**RECALL OF CERTAIN
TITAN/CONSHELF DIN HANDWHEEL RETAINERS**

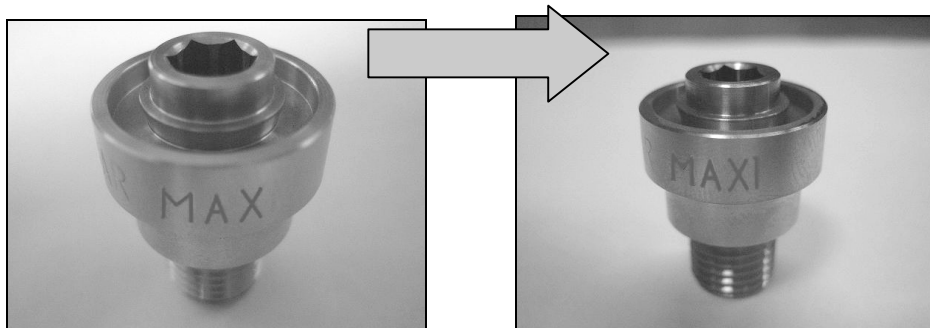
Aqua Lung was recently informed about the breakage, under pressure, of a TITAN/CONSHELF DIN HANDWHEEL RETAINER weakened during service by manual torque loads superior to the recommended values.

Aqua Lung asks all the owners of TITAN DIN regulators whose serial number is lower than 6062501 or TITAN/CONSHELF DIN adaptors that are marked 300 BAR MAX to return their regulator to their Aqua Lung authorized retailer for an upgrade.

The corrective action is replacement of the brass DIN HANDWHEEL RETAINER by another stainless steel DIN HANDWHEEL RETAINER marked 300 BAR MAXI.

All the TITAN DIN regulators whose serial number are above 6062501 and/or whose DIN handwheel retainer is marked 300 BAR MAXI are assembled with a stainless steel DIN handwheel retainer and are not affected by this recall.
